Kadri Land

WEST SPRINGS | SUBDIVISION APPLICATION

ADJACENT NEIGHBOUR OUTREACH SUMMARY

SEPTEMBER 2020

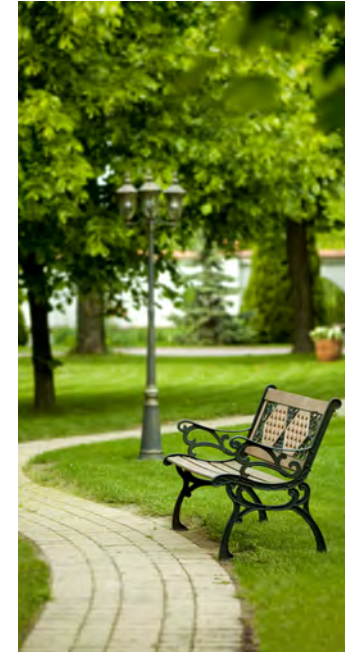
Why the plan provided about 14 meters opening between Unit 1 & 2 in front of largest home (12 West Cedar PT) and completely blocking other units on the west side. It appears is related to relation of owner with 12 West Cedar and is not fair to other neighbor

I attended the web meeting on June 30th, 2020. I have to say my family are very disappointed for this land plan. In my concern, it is ridiculous and unacceptable. We still can't believe on this narrow land (only less 15m width) 4 single houses can be built, honestly the plan is out of our imagination! After reviewed the plan again, below are our concerns,
You guys showed us the examples of similar houses in same situation were already built before (see attached screenshot), but did you realize all these houses were located on corner lots? all of houses do have driveways to their garages? all of houses are facing streets that are width 9.5m or greater?

The plan was developed to join the backyards of units 1 & 2 and group the garages in units 2 & 3. At the detailed development stage, we will look closer at the layout to see if a different configuration will work to balance out the separation distances.

We recognize that some of the examples were corner lots, and some were also interior lots. The examples demonstrate that having a rear yard adjacent to a side yard is a relationship that is planned all throughout the City.

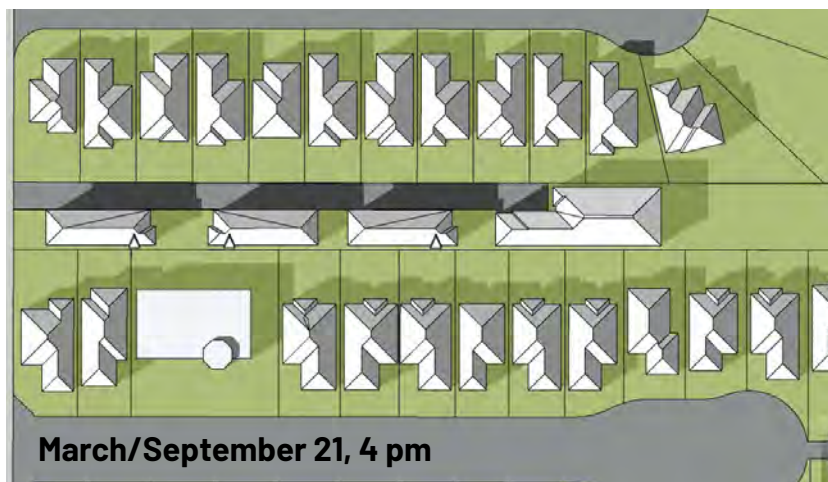
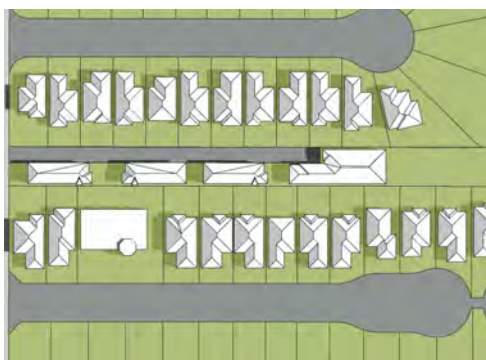
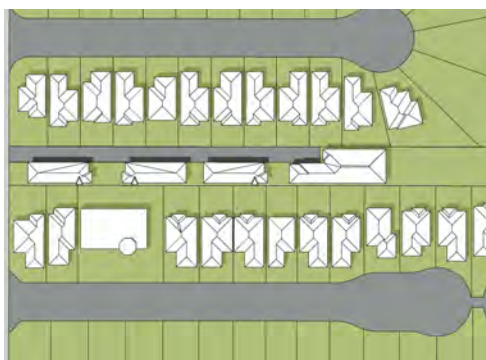
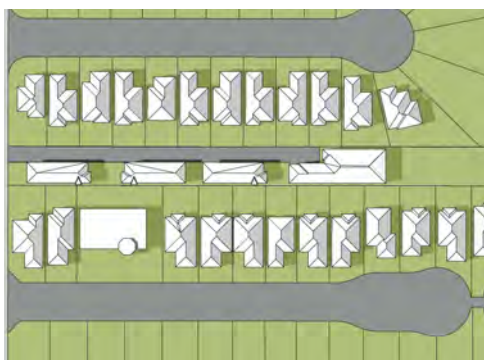
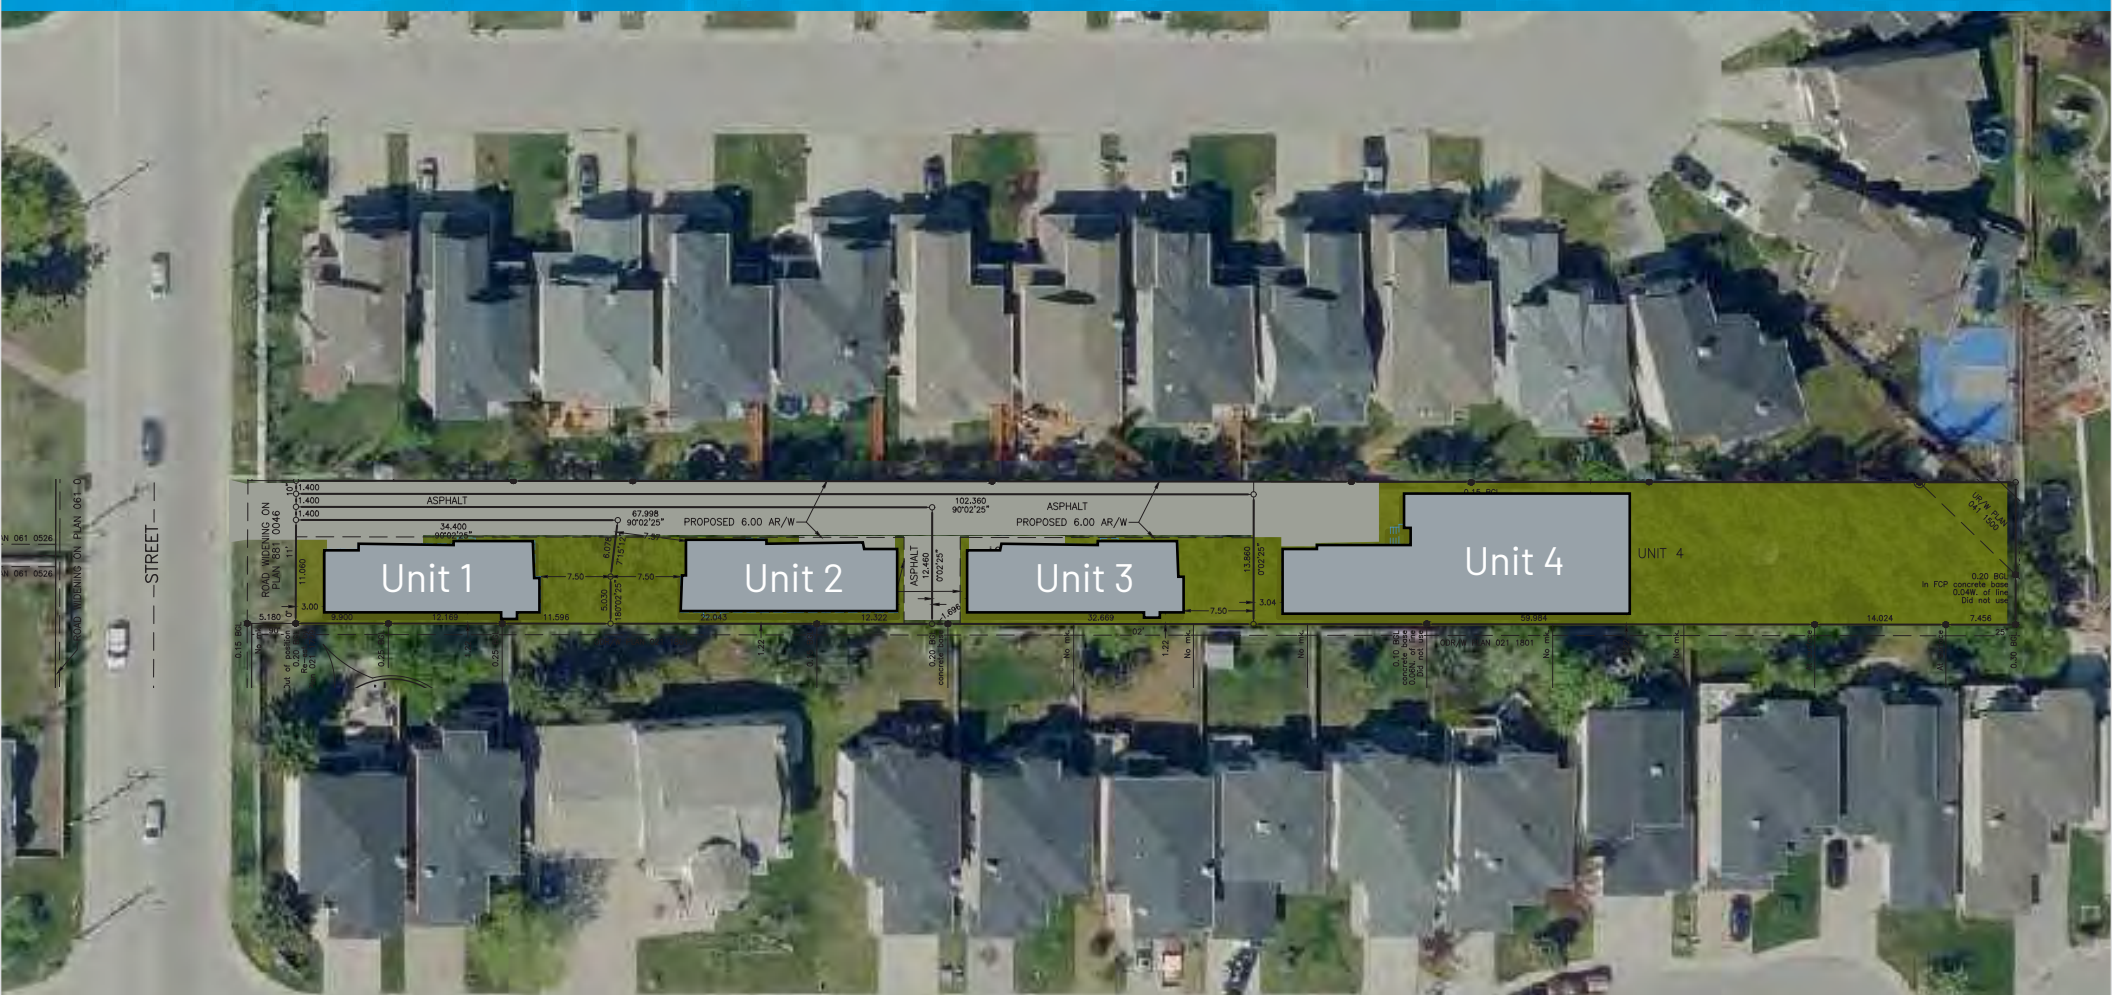
VERBATIM QUESTIONS & COMMENTS	RESPONSE
There are 3 houses that have south backyards that will never see sun	Shadow Studies were shared in the presentation, which can be found in Appendix A and B. December is a month that affects all homes throughout the City and most homes do not see the sun now with the existing trees.
Shadows from trees are more welcome than those from houses	We appreciate your feedback.
and sun still comes through the trees	We appreciate your feedback.
Overshadowing: I would like to see this information again if the presentation can be sent out.	Shadow Studies were shared in the presentation, which can be found in Appendix A and B.
Could you please clarify the shadowing. If you aim for the height of the surrounding buildings, how can the shadow not affect the surrounding lots if you keep only 6 meter distance to the lots located in the north.	The Shadow Studies were prepared using a house that is between 10m-11m tall. The software that is used automatically calculates the sun angle at times over the year. It is standard practice to show March 21, June 21, September 21 and December 21.

Could you please share the details of the calculations for the shadowing by email?	The Shadow Studies were prepared using a house that is between 10m-11m tall. The software that is used automatically calculates the sun angle at times over the year. It is standard practice to show March 21, June 21, September 21 and December 21. Shadow Studies were shared in the presentation, which can be found in Appendix A and B.
Can you please explain why you can provide details on shadowing but cannot provide details on the dimensions of the single family dwellings?	It was an oversight for us not to have the dimensions from the designer available for the public meeting. More details about the proposed development dimensions have been shared in Appendix C. The Shadow Studies were built from the footprint (as shown on the concept plan) and used the single family height of the R-1S - a house that is between 10m-11m tall.

Shadow studies have been completed and were shared in the presentation, see Appendix A & B. Most shadows are retained within the site. The current trees create more of a shadow today than the new homes, though we understand that trees provide a nice buffer.

Waste & Recycling Services – Collection Vehicle Access

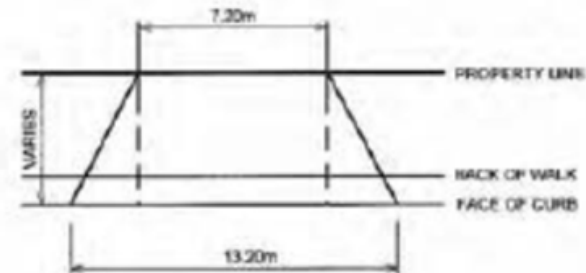
- a. Provide a scaled plan (1:200 / 1:300) indicating the vehicle sweep and turning movement for collection vehicles. Refer to the "Development Reviews: Design Standards for the Storage and Collection Waste" found at: <http://www.calgary.ca/UEP/WRS/Pages/Commercial-Services/Development-Permits-Waste-Recycling.aspx>
- b. Indicate that the maximum distance the collection vehicle will reverse is two truck lengths.
- c. Provide a minimum 5.0m vertical and horizontal clearance for vehicle access.
- d. Provide a City standard turnaround area or a looped route to allow the collection vehicle to both access and egress the site by driving forward.

7. **Prior to decision**, amend the plans to provide a minimum 7.2m wide access right-of-way, which is required for two way vehicle traffic, as well as to accommodate for the vehicle back out maneuver from the proposed garages. Also, amend the vehicle swept paths to be a TAC large 4 door sedan ensuring at least 0.5m of clearance from all obstacles, and no more than 3 back and forth movements to enter and exit all the garages. Anything more than this is overly onerous.

8. At the time of Development, a standard 7.2m wide driveway with 3m wide flares will be required to access the site off 77 Street S.W. (See image below). Also, be aware that the flares are not permitted to cross lot lines without permission from the affected landowner. **Prior to decision**, amend the plans to confirm the direction that is to be taken, ensuring appropriate sight triangles for vehicle/ pedestrian safety are provided. Refer to the diagram below.
